Discontinuation of the FR-D700 and FR-F700PJ Series General-Purpose Inverters

Date of issue	Published in October 2025 Revised in November 2025	Title	Discontinuation of the FR-D700 and FR-F700PJ Series General-Purpose Inverters	Mitsubishi Electric Corp., Nagoya Works 5-1-14 Yada-minami, Higashi-ku, Nagoya 461-8670 Tel.: +81 (52) 721-2111 Main line

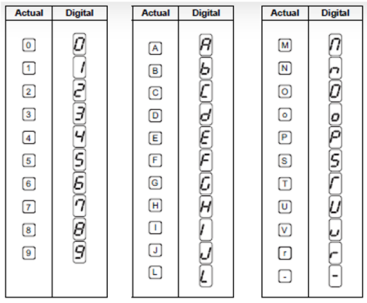
Item	Current model	Successor model	Supplemental information
Operation panel	Only the upper 4 digits of the parameter setting value can be displayed and set. For parameters that allow values from the hundreds place to the second decimal place, such as 120.00 Hz, only the first decimal place can be set (120.0 Hz).	Up to 5 digits of the parameter setting value can be displayed and set. For a 5-digit value, the upper 1 digit and the lower 4 digits of the value are displayed alternately. However, for parameters that allow values from the hundreds place to the second decimal place, such as 120.00 Hz, only the first decimal place can be set (120.0 Hz).	-
	Characters are indicated by the 7-segment display as follows.

Characters are indicated by the 7-segment display as follows. (Changes from the current model are indicated in red.) 	
	The parameter is indicated by displaying "P." and the parameter number.	For parameters smaller than Pr.1000, "P" and the parameter number are displayed. For Pr.1000 or larger parameters, "Pr." and the 4-digit parameter number are displayed alternately.

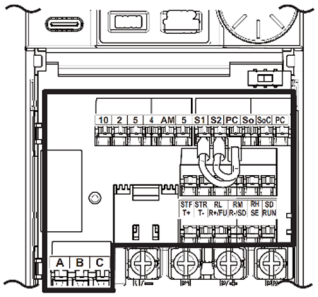
</td><td>Although spring clamp terminals are used as well as on the FR-F700PJ, the terminal layout is different.
[Changes of the terminal layout]
· Terminal FM is removed and terminal AM is added.
· Terminal SC is removed and terminals PC and SoC are added.
· Terminal AU is removed and terminal RL is added.
